# UNITED STATES PATENT AND TRADEMARK OFFICE

APPLICATION NO.	FILING DATE	FIRST NAMED INVENTOR	ATTORNEY DOCKET NO.	CONFIRMATION NO.
10/803,399	03/18/2004	Stephan K. Barsun	200313138-1	5524

<b>Office Action Summary</b>	<b>Application No.</b>	<b>Applicant(s)</b>	
	10/803,399	BARSUN ET AL.	
	<b>Examiner</b>	<b>Art Unit</b>	
	Zachary M. Pape	2835

### DETAILED ACTION

Fig 1a

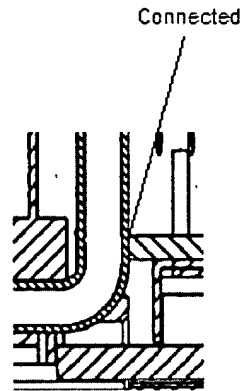
With respect to claim 4, the claim recites, "the second base is configured to conduct heat from the central processing unit to the second array of fins without conducting heat to the first base" however as illustrated in Fig 5, the heat pipe (102)

which is thermally connected to the second base appears to be thermally connected to the first base (90) as well (See Figs 1a, and 1b below). Thus the recitation, “without conducting heat to the first base” appears to be incorrect.
